# ADDENDUM NO. 3

DATE: **April 27, 2026**

PROJECT: **Wastewater Treatment Plant Improvements**

C & S PROJECT NO.: **T7040.003**

| DATE: 03/16/26 | SHEET NO.: 13 |

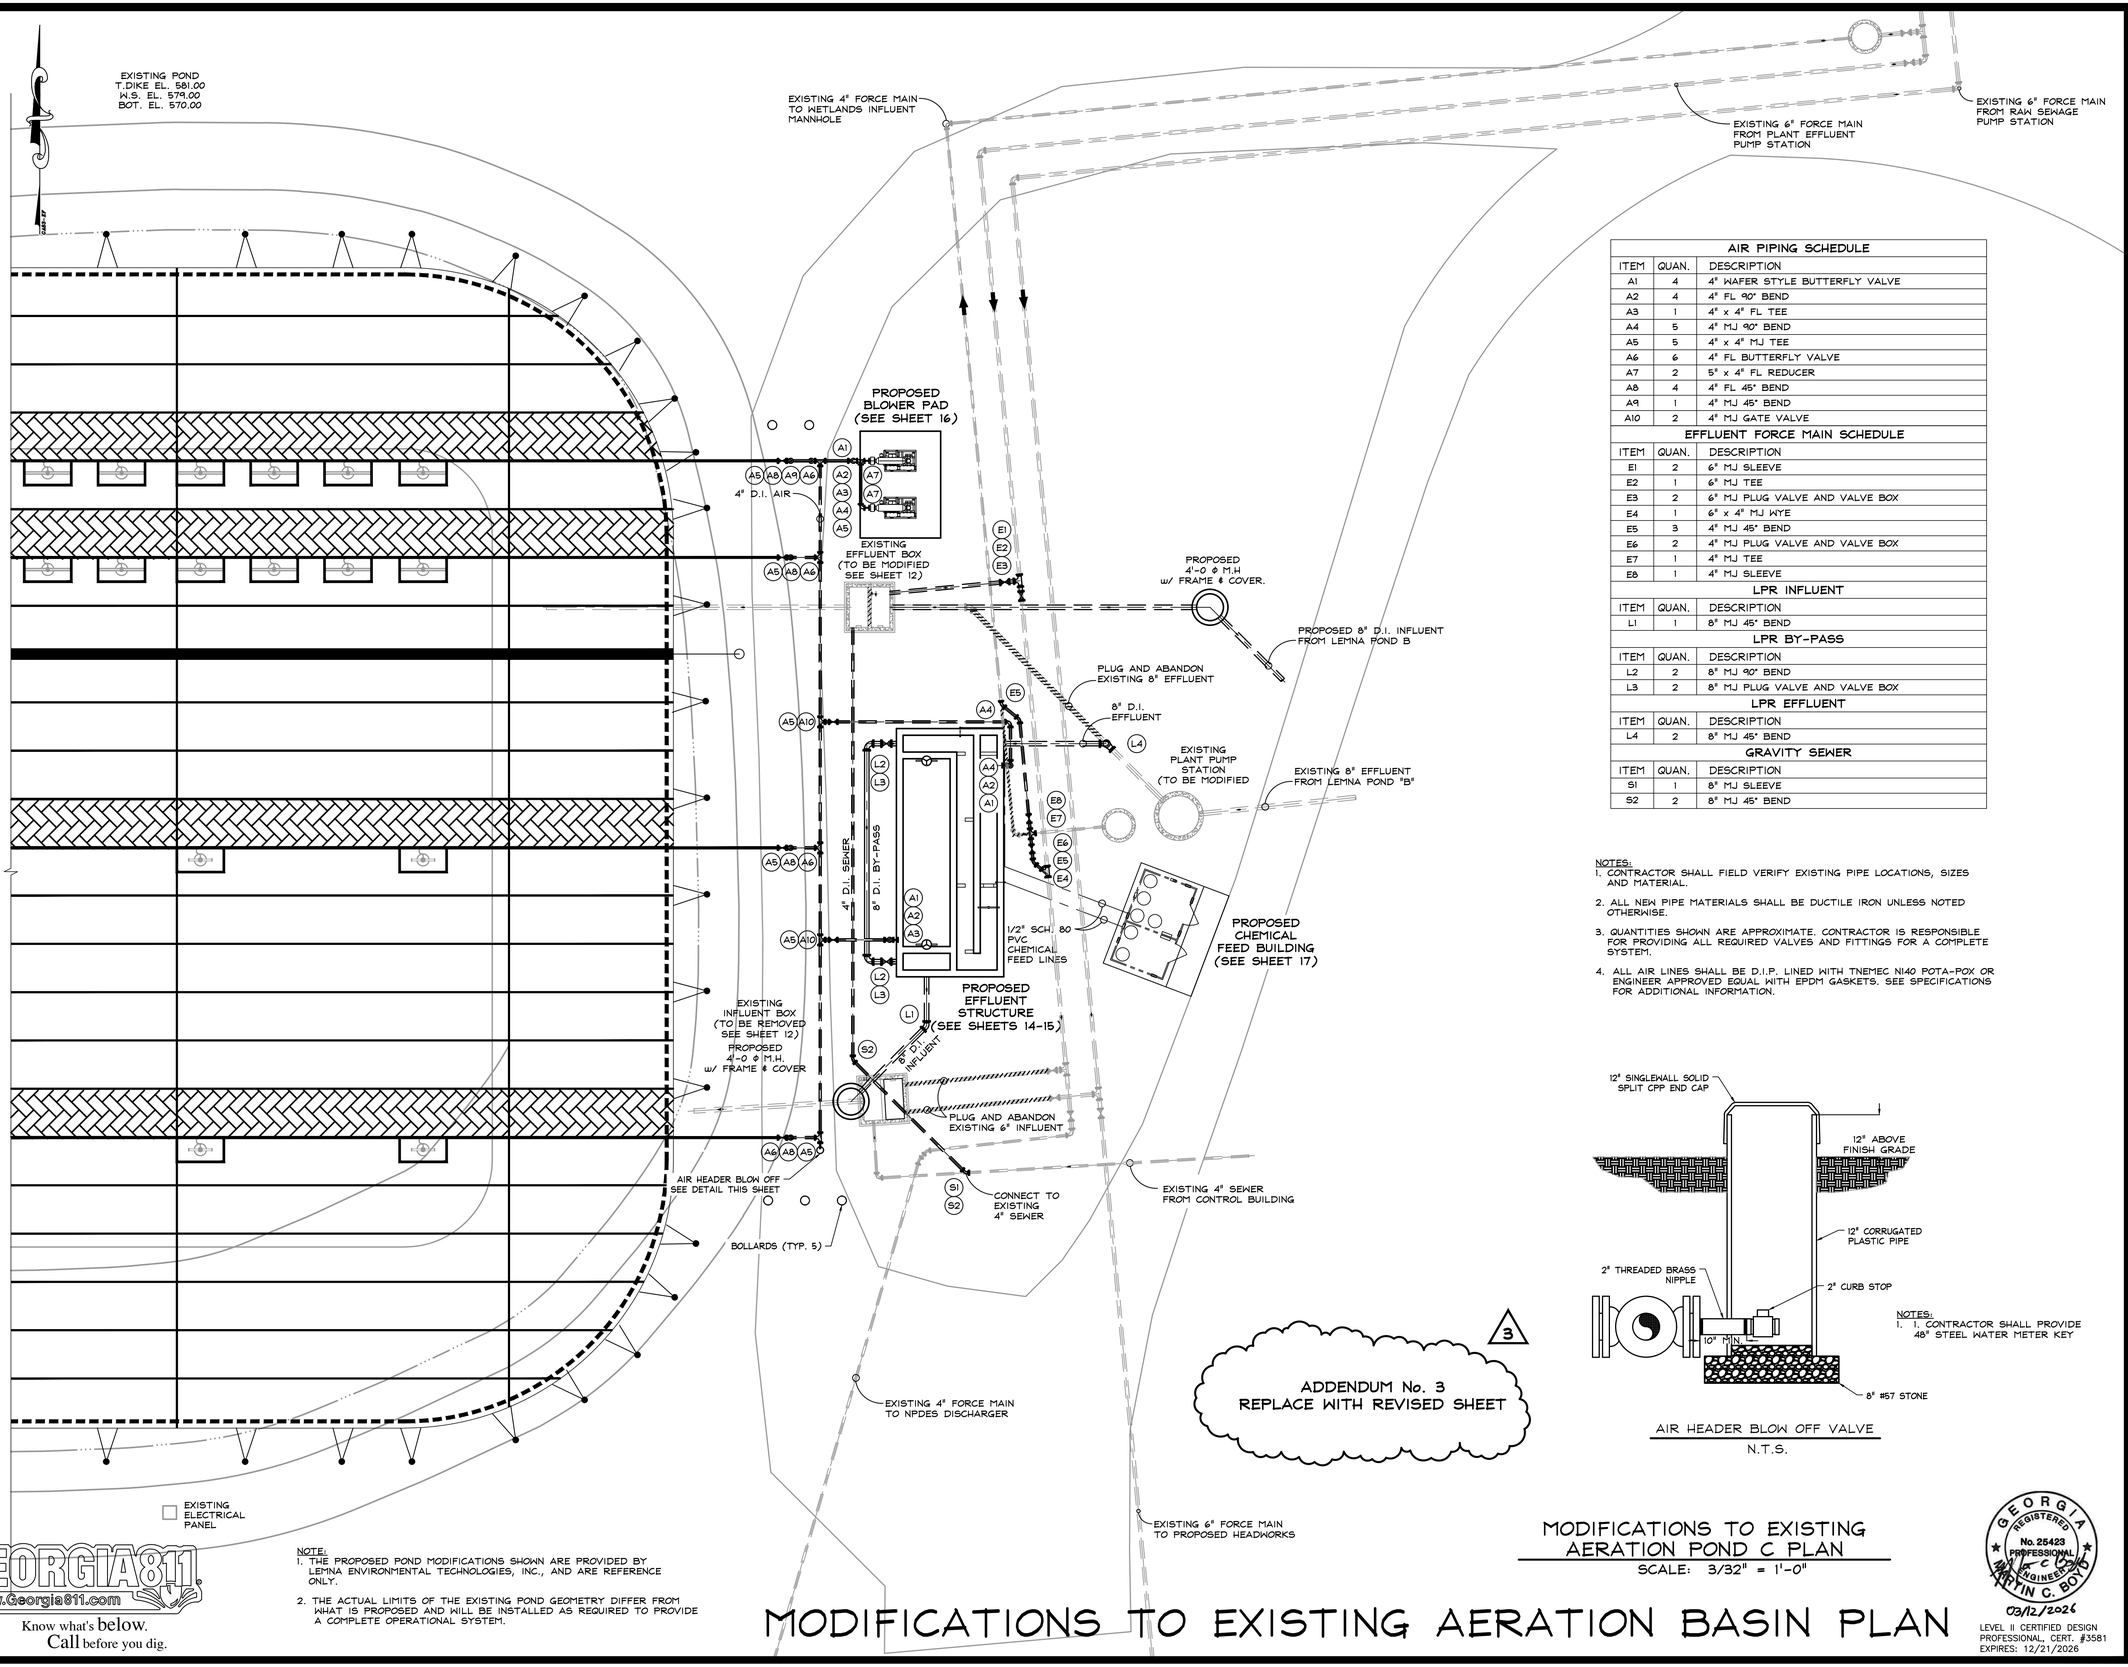
1. **Question:** On plan sheet 13 under the air piping schedule there are 4" MJ gate valves with boxes called out under note A6. On plan sheet 20, Lemna detail view 2 shows what looks to be wafer style butterfly valves stubbed above the berm to be tied into the HDPE lines. Are we to include those additional lug valves above ground in addition to the buried gate valves or should it just be one or the other?

3. **Question:** Sheet 18 calls for a 4" blow off valve 'By Others'. Is this valve not a part of this contract? Or is it a part of this contract, just not provided by the equipment supplier?
   **Answer:** The 4" blow off valve is a part of this contract. It is to be provided by the Contractor. See revised Sheet 13 included in this Addendum for blow valve location and detail.

**Answer:** The Contractor shall furnish and install butterfly valves. On Sheet 13 of the Drawings, Item A6 will be changed to 4" FL BUTTERFLY VALVE. See revised Sheet 13 included in this Addendum for air piping schedule. Valve boxes are no longer required since the butterfly valve will not be buried; however, a concrete pipe support will be necessary to support the pipe and valve and the Contractor should use the detail for pipe support as shown on Sheet 25.

| AIR PIPING SCHEDULE | | |
|---|---|---|
| A6 | 6 | 4" FL BUTTERFLY VALVE |

AIR HEADER BLOW OFF VALVE
N.T.S.

# PROPOSED AERATION EFFLUENT STRUCTURE PLAN & SECTION

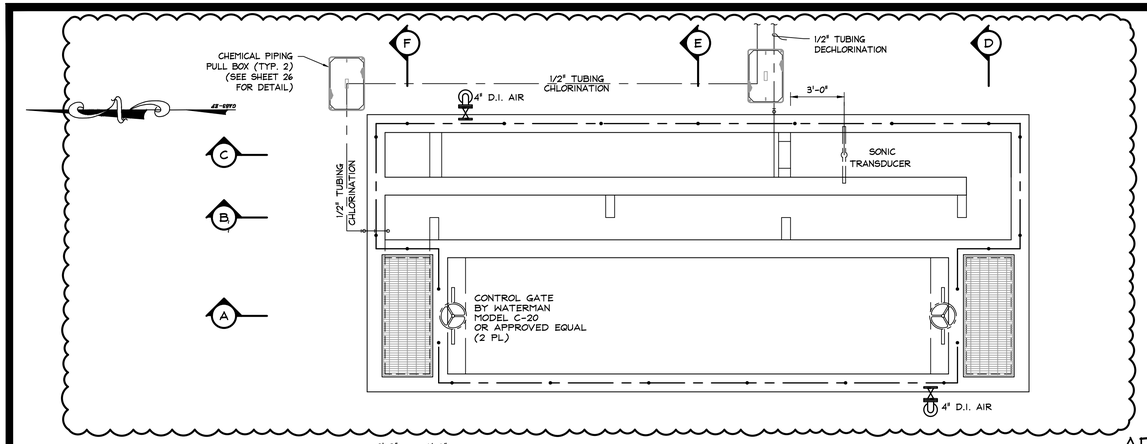
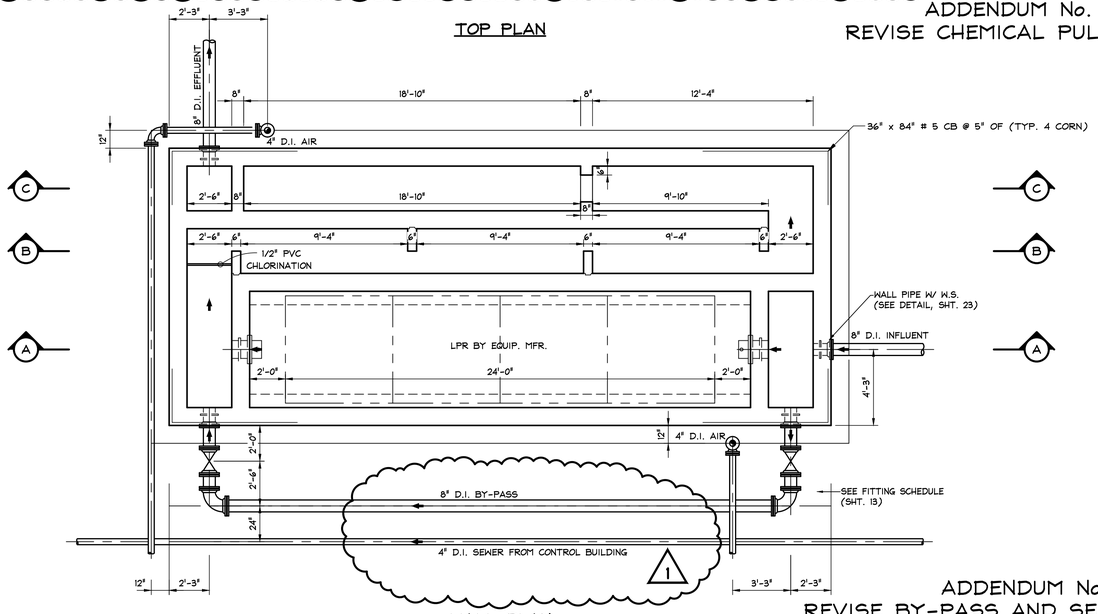
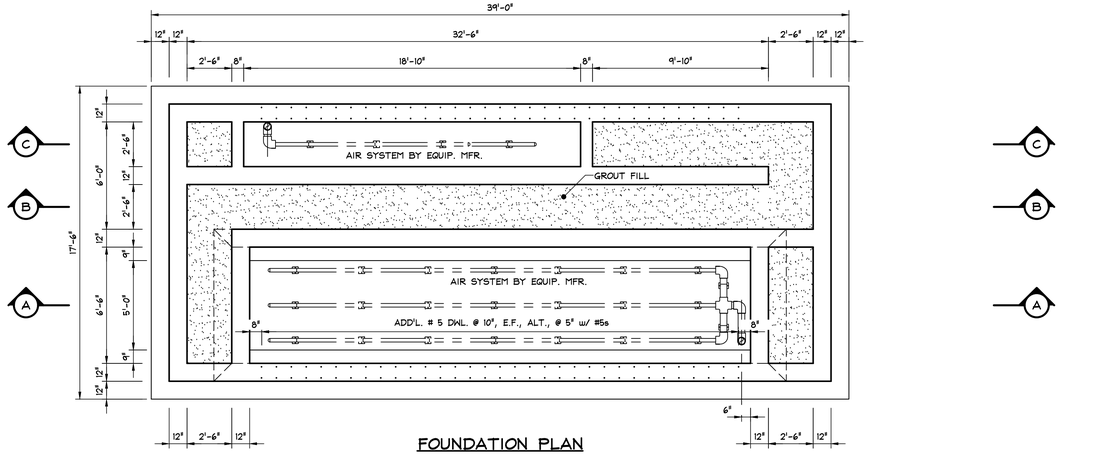
5. **Question:** The drawings show a chemical piping pull box at the chemical storage building, but no pull boxes at the Polishing Reactor structure. Are pull boxes at the Polishing Reactor structure required for the transition from tubing to PVC piping?
   **Answer:** Yes, chemical piping pull boxes will be required. The detail is shown on Sheet 26 per this Addendum. The locations of the pull boxes are shown modified sheet 14 included in this Addendum.

ADDENDUM No. 3
REVISE CHEMICAL PULL BOXES

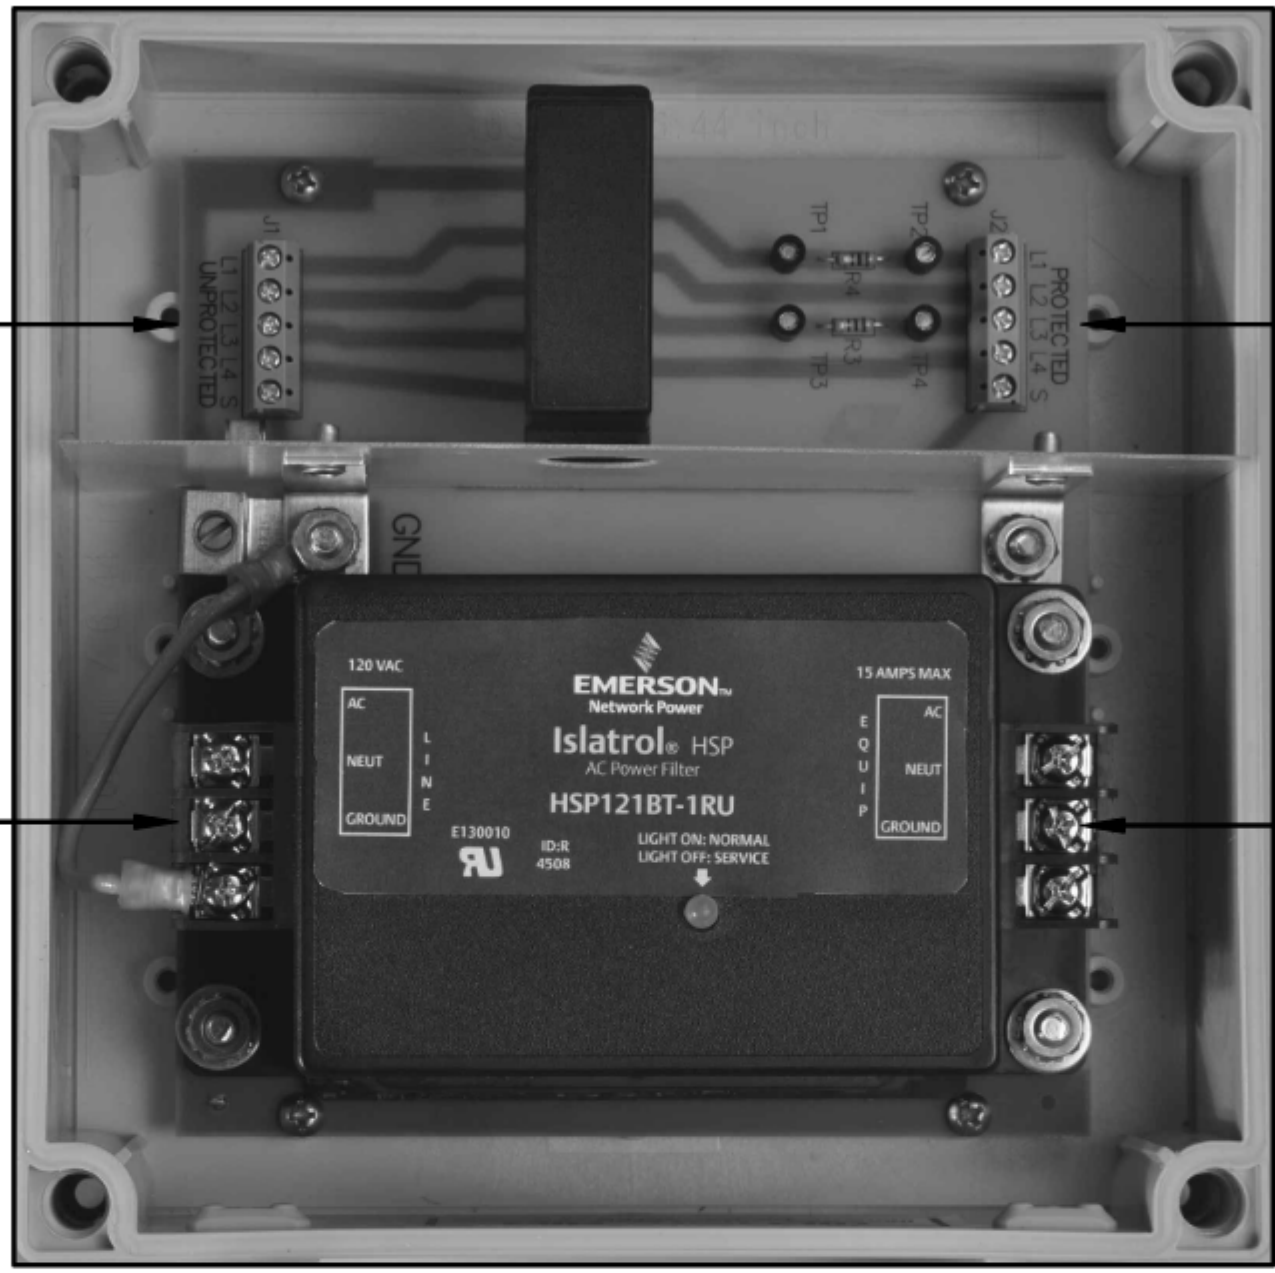
18. **Question:** E.8 indicates a Surge Protector for FIT-200, but no related specification is included. Please provide specification.
    **Answer:** The relevant specification is included in this Addendum.

1) SURGE SUPPRESSOR EMERSON EDCO SLAC SERIES AC POWER/SIGNAL SURGE PROTECTOR MODEL NUMBER SLAC-22036 OR EQUAL. SUPPRESSOR SHALL BE PROVIDE IN A NEMA 4X STAINLESS STEEL ENCLOSURE.
2) PROVIDE SURGE SUPPRESSOR FOR ALL 4/20mA FIELD INSTRUMENTS; FLOW, LEVEL, DO/ORP TRANSMITTERS ETC.
3) CONNECT GROUND TERMINAL TO LOCAL GROUND USING #12 AWG WIRE MINIMUM.
4) KEEP 120 VAC POWER FEED SEPARATE FROM LOW VOLTAGE 4/20mA FEED.
